Illinois Power Company
Clinton Power Station
P.O. Box 678
Clinton, IL 61727
Tel 217 835-8881

Subject: Clinton Power Station
Proposed Resolution of Issues Related
to NRC Review of Inservice Testing Program

RELIEF REQUEST 2008 (Revision 3)

(GRAPH 1)

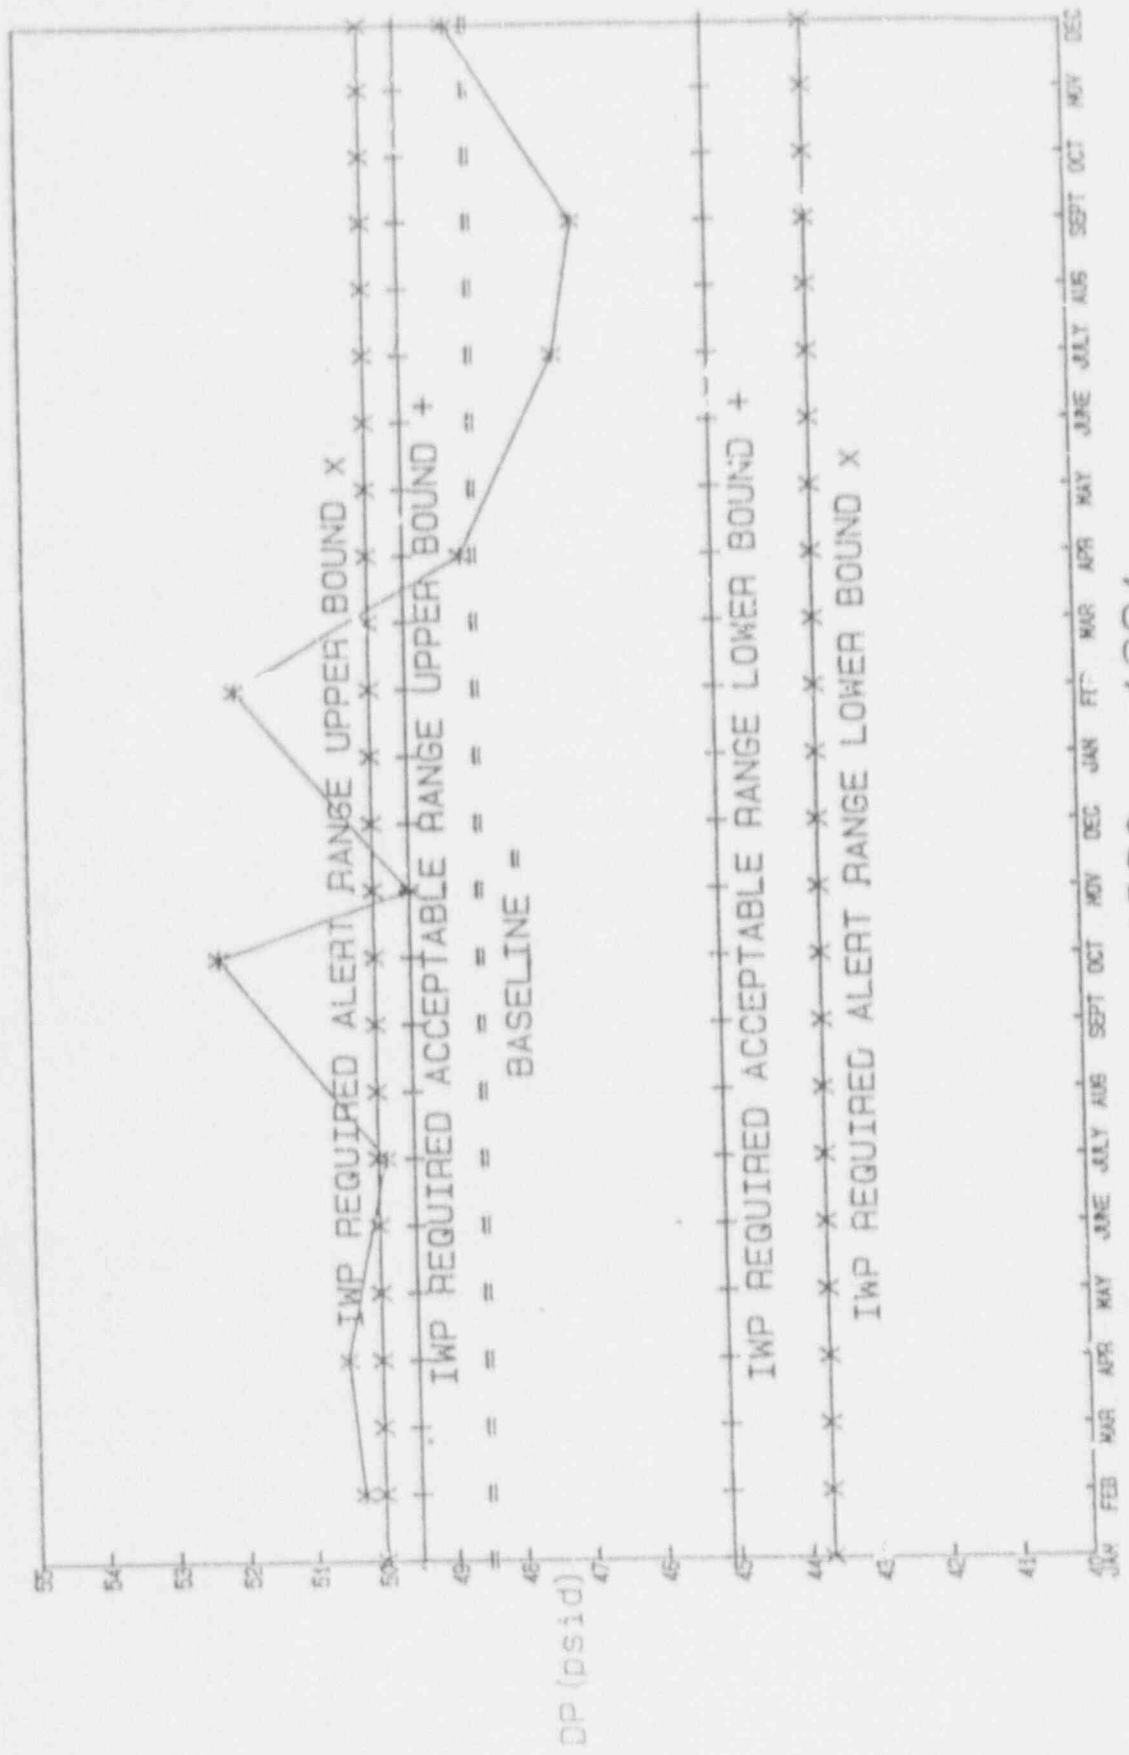
Because the water-leg pumps operate at a low DP and the Code specified acceptable ranges are based on a percentage of the baseline, a small increase in DP can result in the pump reaching the alert or action range when the pump is operating within design parameters.

Using data for the HPCS water-leg pump (1E22-C003) as a representative example, which has a baseline DP of 48.5 psid, the Code-required acceptable range varies from 45.1 to 49.5 psid, or less than 4.4 psid (SEE GRAPH 1). Likewise the Code-required alert range for 1E22-C003 varies from 43.7 to 50 psid, for a range of 6.3 psid.

(GRAPH 2)

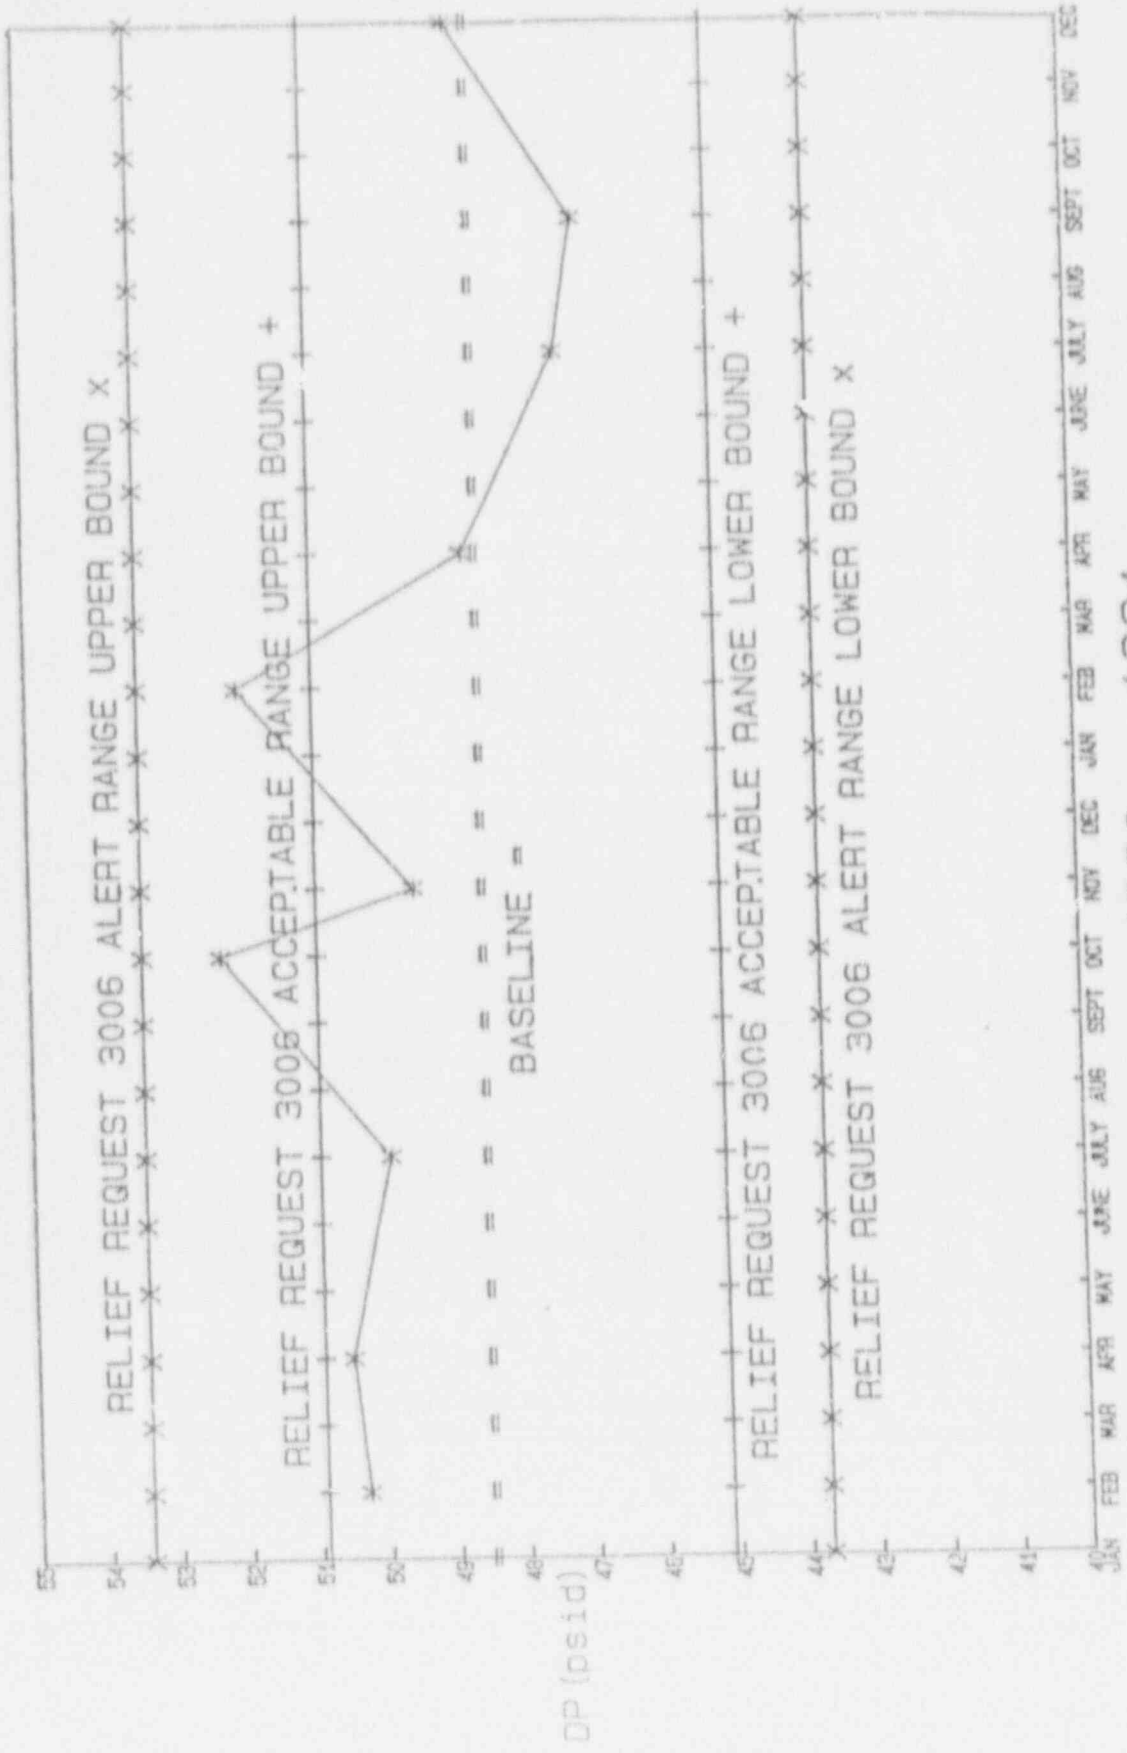
CPS believes the lower acceptable and alert range boundaries (0.93 and 0.9 of baseline DP) are achievable without undue hardship. However, based upon the Code required upper acceptable and alert range boundaries of 1.02 and 1.03 baseline DP) a deviation of only 1.0 psid above baseline DP is sufficient to force any of the CPS waterleg pumps onto increased frequency, and an increase greater

Based upon CPS's operating experience, CPS feels that the revised upper ranges will provide good indications of pump degradation without the unnecessary burden of requiring the pumps to be tested on increased frequency or declaring them inoperable for minor (1 to 2 psid) variations in DP (SEE GRAPH 2). CPS has evaluated minor fluctuations of this type and has determined that this performance is not an indication of pump degradation, and the pumps are operating within design allowable limits.

Acceptable Range	(0.93 to 1.05) x (baseline dp value)
Alert Range	(0.90 to 1.10) x (baseline dp value)
Action Range	< (0.90) x (baseline dp value) > (1.10) x (baseline dp value)

HYDRAULIC CONTROL UNIT (2/1/1968)
171015AL - 1433

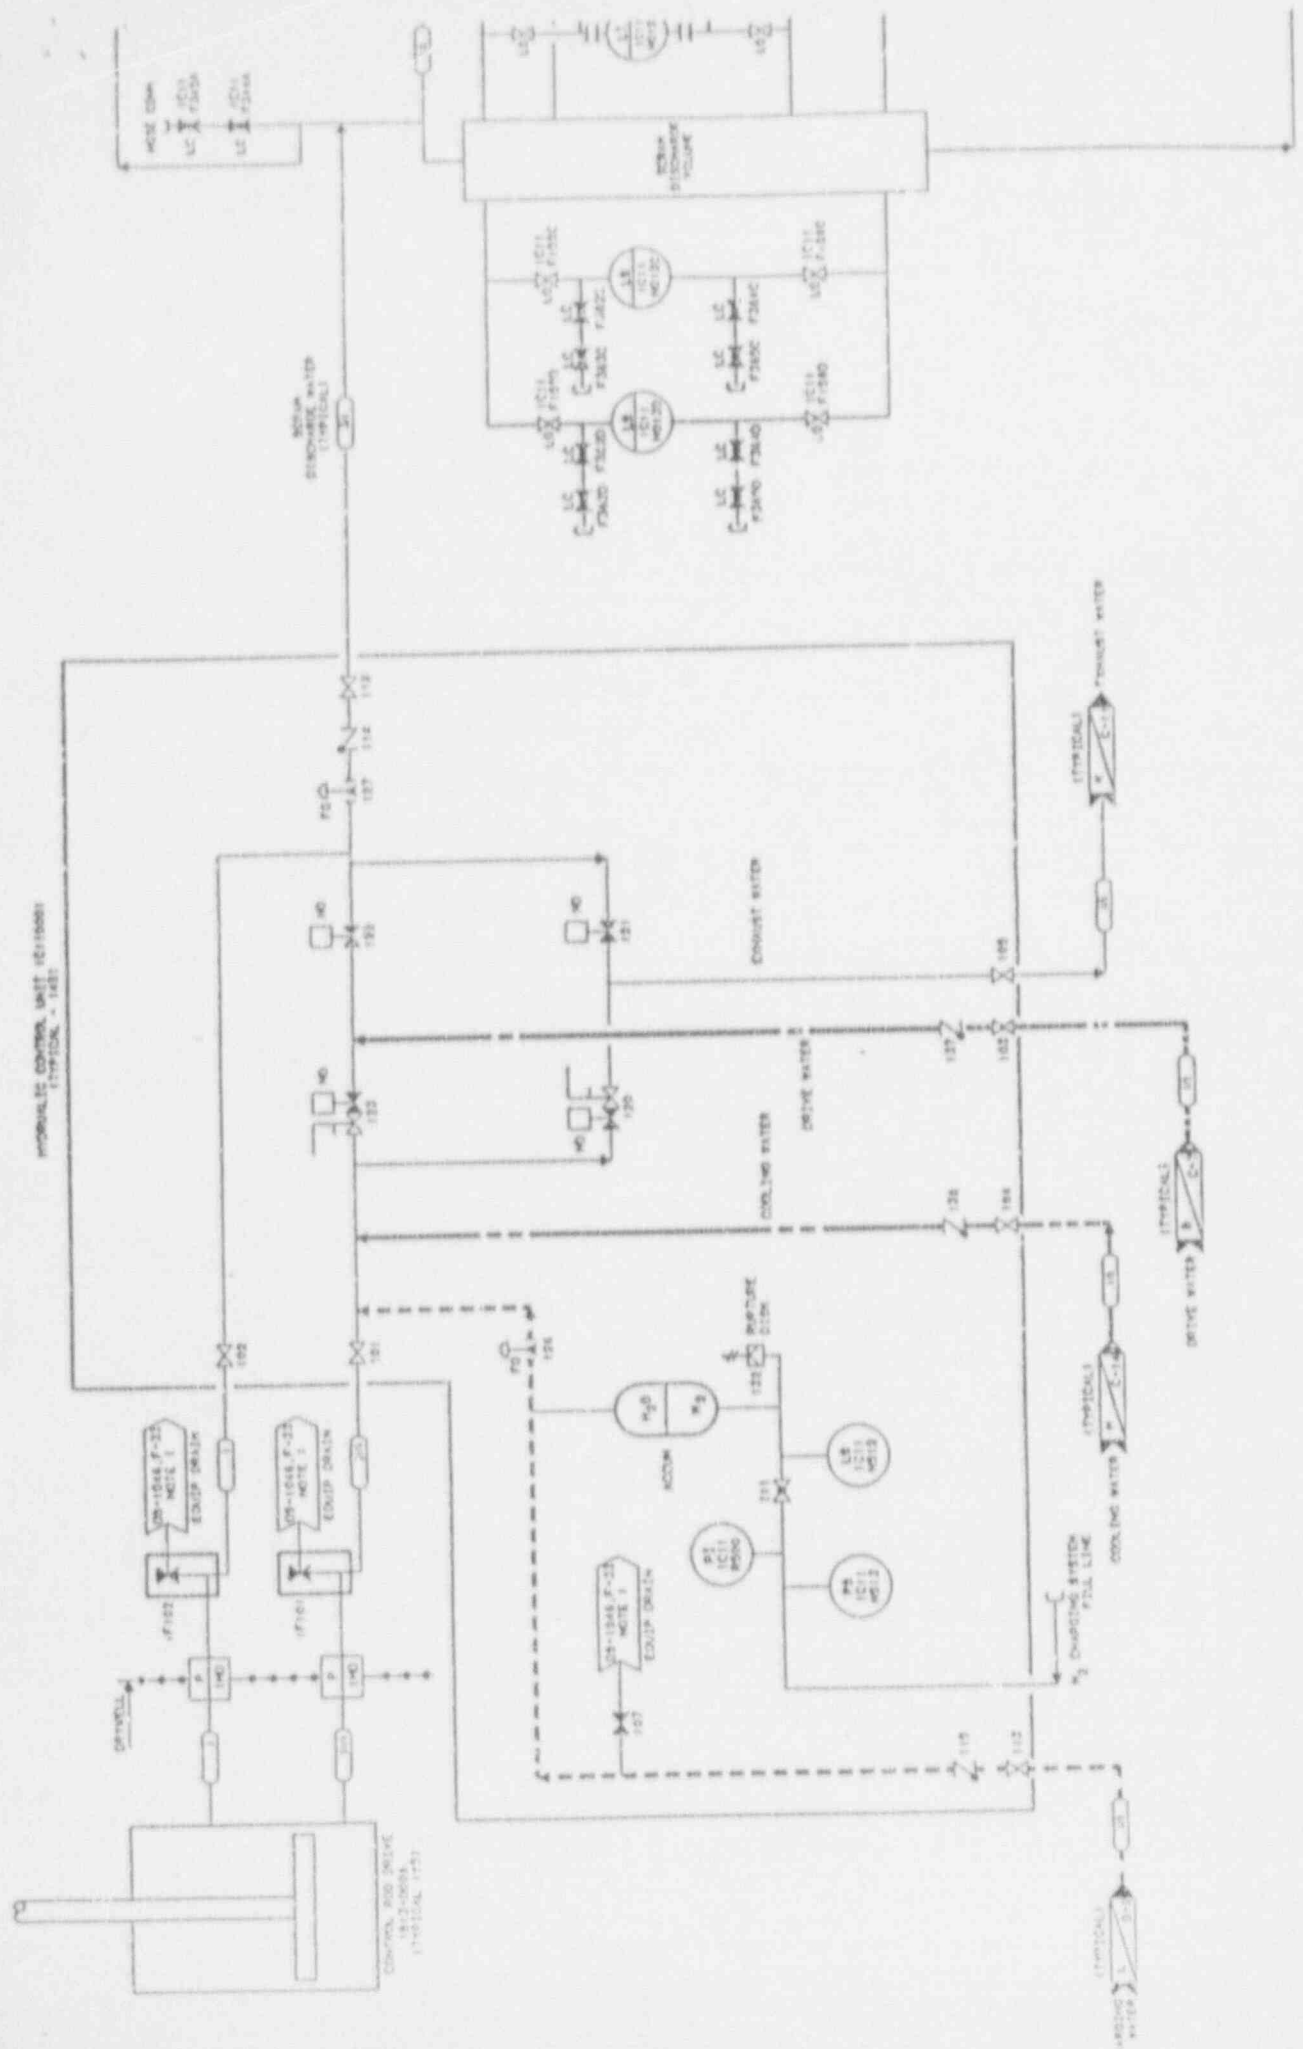
Valves 1C11-126, 127 and 139 (typical of 145 each) are power operated valves which actuate (open) to scram the control rod drives. Valve 1C11-114 (typical of 145 each) is the scram discharge check valve. Refer to the attached schematic drawing for the system.

These valves operate simultaneously when a scram signal is present. As these valves are skid mounted with no provisions for testing, it is not practical to individually test each valve without extensive modifications, which would create a financial hardship to Illinois Power Company. The current testing, per Technical Specification 4.1.3.2, monitors individual rod scram time. This testing does not measure stroke time for the power operated valves or provide specific exercising verification for either the power operated or check valves. However, it does assure that each valve functions properly to allow the rod to move to its safety position in the required time.

Testing of the control rod drive hydraulic control units per Technical Specification 4.1.3.2 will be performed in lieu of the Code requirements. The

Technical Specifications require all rods to be tested following any core alterations and any prolonged outages (120 days). Ten percent of the rods are tested on a rotating basis every 120 days and any rod requiring maintenance is tested upon completion of the work. This is in accordance with NRC Generic Letter 89-04, Attachment 1, Item 7.
